DOCUMENT CHANGE REQUEST

DCR number 264	Changes required for: General	Originator: Ron Fidler
Date: 2006/07/24	Date sent: 2006/07/24	Organisation: ESA/ESTEC
Status: IMPLEMENTED

Title:	Transistors Low Power NPN, based on type 2N3700		
Number:	5201/004	Issue:	1

ESCC Detail Specification No. 5201/004

1.6.1 Metal Can Package (TO-18) - 3 lead

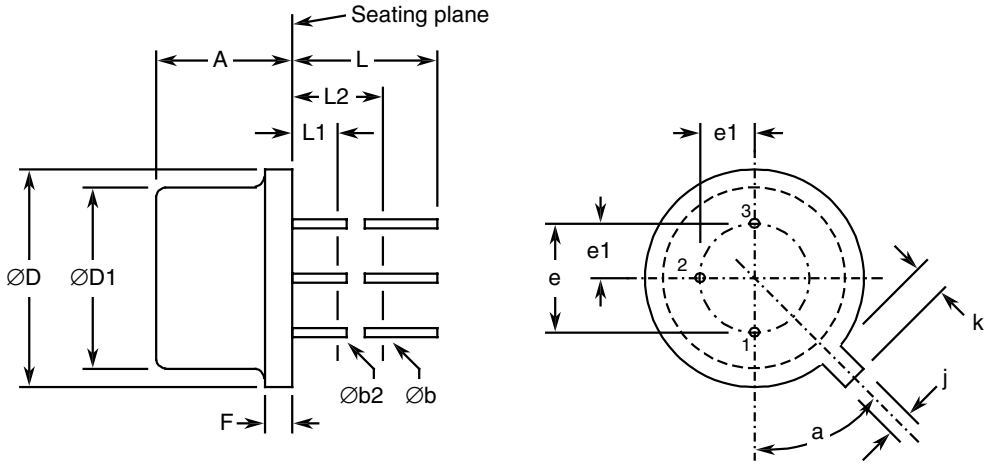
6. Figure 2(a) - Dimensions .e. (formerly fa) and .a. changed from "T.P." to "BSC". The drawing harmonized with TO-18 outlines for similar STM components.

Symbols	Dimensions mm		Notes
	Min	Max	
A	4.32	5.33	
Øb	0.406	0.533	2, 3
Øb2	0.406	0.483	2, 3
ØD	5.31	5.84	
ØD1	4.52	4.95	
e	2.54 BSC		4
e1	1.27 BSC		4
F	-	0.762	
j	0.914	1.17	
k	0.711	1.22	5
L	12.7	-	2
L1	-	1.27	3
L2	6.35	-	3
a	45° BSC		1, 4, 6

1.6.2 Chip Carrier Package (CCP) - 3 terminal

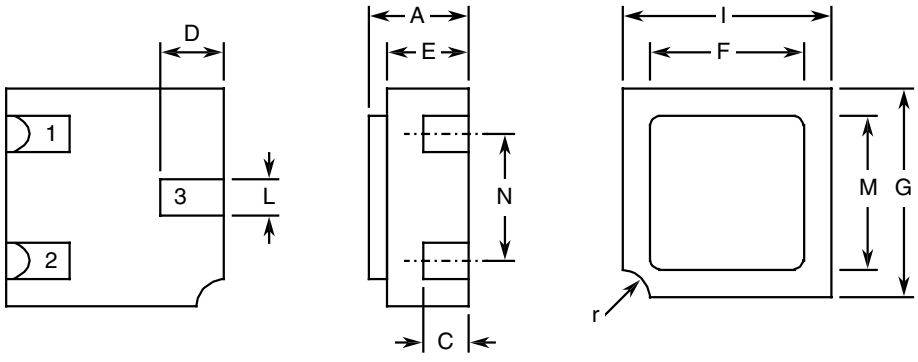
7. Figure 3 - Note for the CCP stating that the lid is not connected to any terminal added.

NOTES:
1. For TO-18, the collector is internally connected to the case.
2. For CCP, the lid is not connected to any terminal.
